Paramount
resources ltd.

**Re: Paramount Resources Liard East Environmental Assessment
EA Report Conformity
Your File EA00-003**

**Re: Paramount Resources Liard East Environmental Assessment
EA Report Deficiency Statement
Your File EA00-003**

SCHEDULE 11**REFERRED TO IN SECTION 8.148 OF THE OIL AND GAS CONSERVATION REGULATIONS
EQUIPMENT SPACING FOR WELL SERVICING CONVENTIONAL WELLS**

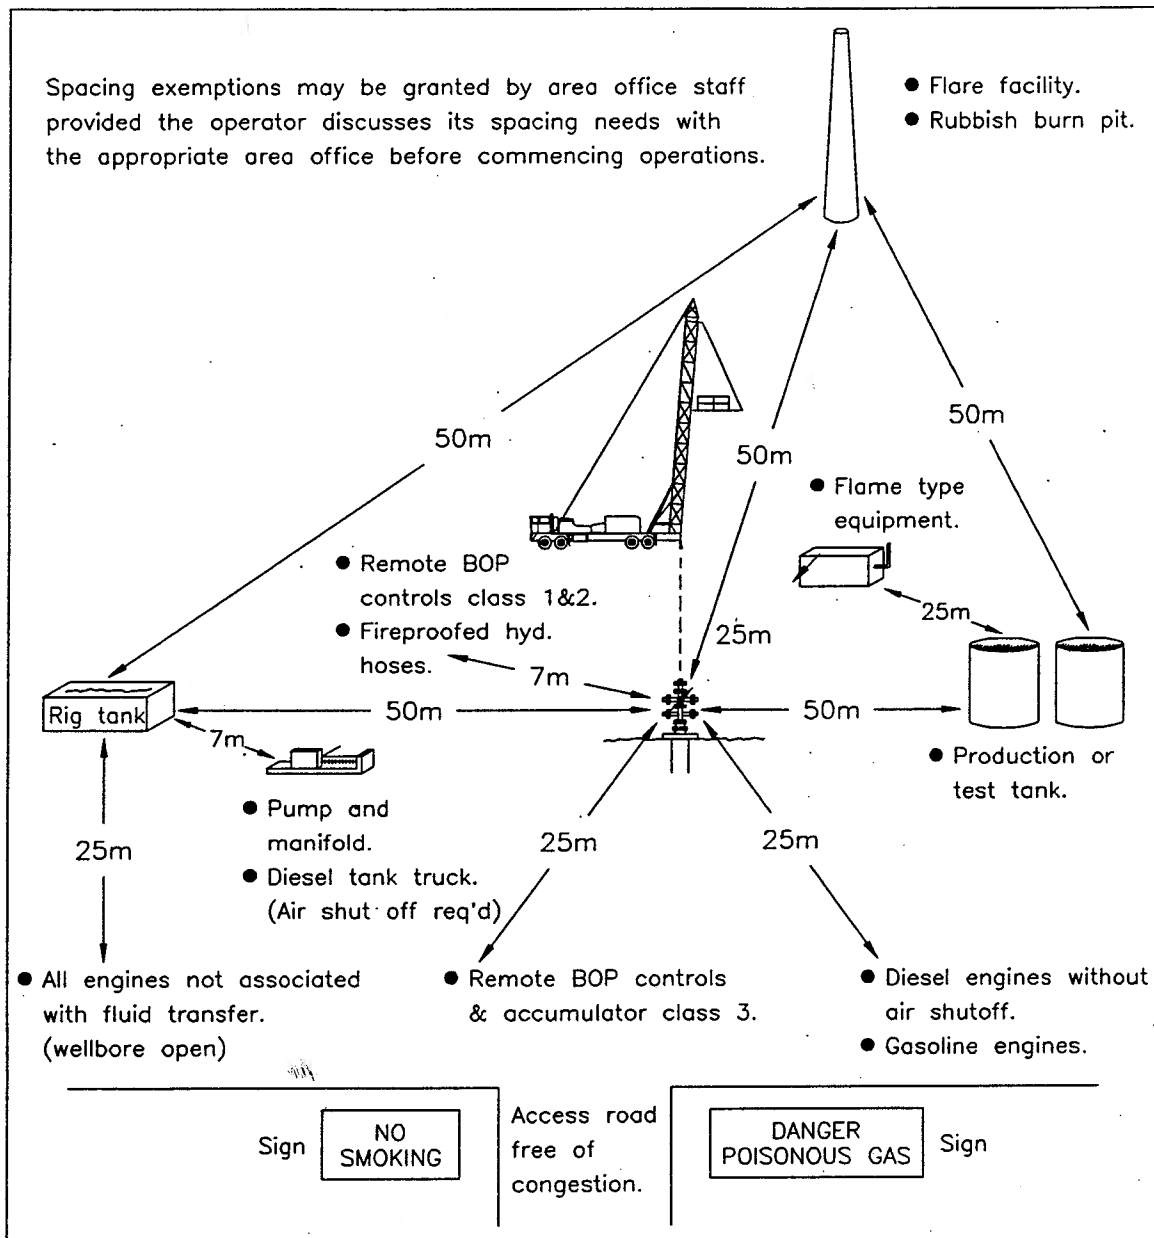
In addition, Joe Acorn requested additional information supporting Paramount's justification on minimum wellsite sizes. Please refer to the attachments

In particular, please note Schedule II, Equipment Spacing For Well Servicing Conventional Wells which indicates that a minimum 50 meters on each side of the wellhead is required to space the rig tank and production or test tanks. This 100 meter distance in addition to space required for clearance from the edge of the lease (ie: buffer zone from tree line), berms and work space supports a minimum lease size of 110 x 110.

Figure 4.2 TYPICAL LEASE LAYOUT

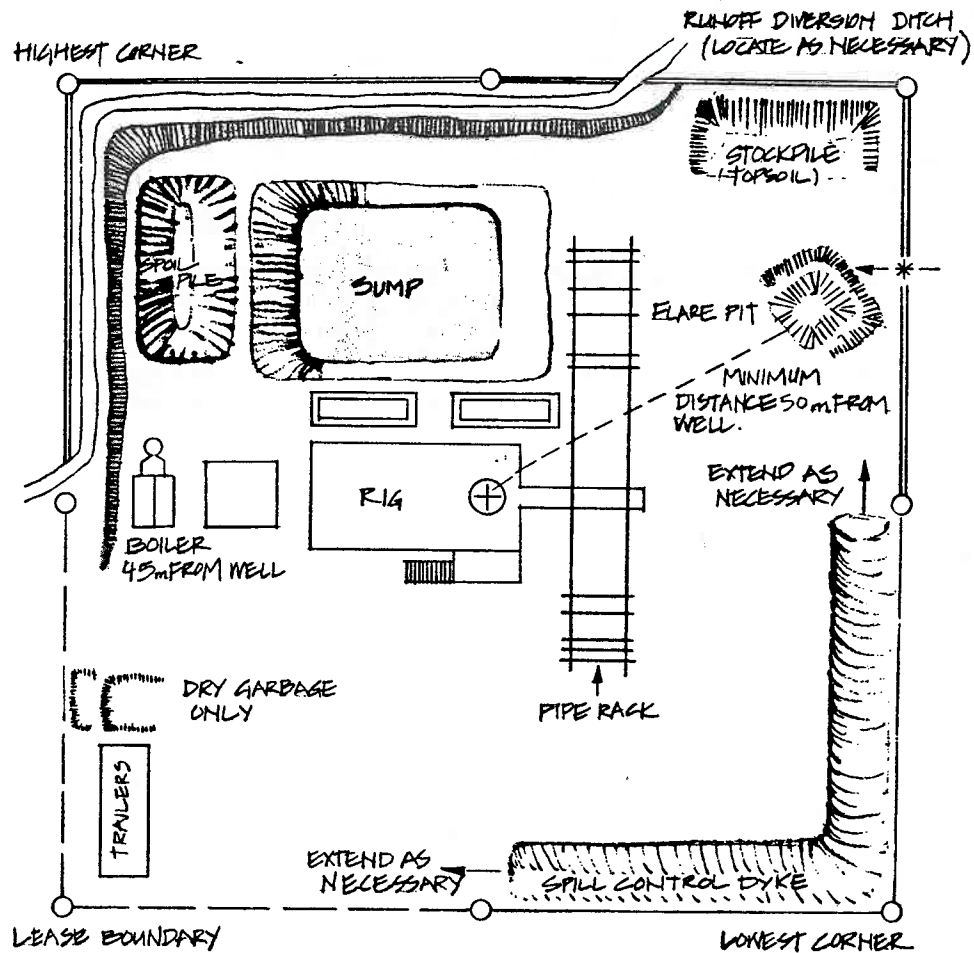
Request: Please provide detailed descriptions, calculations and diagrams that demonstrate why Paramount is requesting minimum well site sizes of 110 m x 110 m.

1. A typical well site size in Alberta is 100 m x 100 m, which is accomplished with a minimum spacing requirement of 50 m from the wellhead to the flare stack. Given that the NEB only requires 40 m minimum spacing from the wellhead to the flare stack in the NWT, why can't the proposed well sites be smaller in the NWT than in Alberta?
2. The typical lease layout diagram that Paramount provided contains a sump, which occupies a significant portion of the well site. Given that

The typical well-site layout provided to the MVEIRB by Paramount in the June 15, 2001 was modeled after the typical well-site layout (non-permafrost) suggested in the Indian and Northern Affairs Canada's Environmental Operating Guidelines: Hydrocarbon Well-sites in Northern Canada. In Paramount's view, the rectangular or square lease provides the opportunity for maximum use of a given area, particularly in treed areas, respecting safety setback requirements. However, in the event that there is an environmental advantage to creating a non-square lease (e.g., round the corners), Paramount will evaluate that option against the

required setback distances to determine the feasibility. It may be that more area might have to be cleared to achieve a non-square lease that meets the safety setback distances.
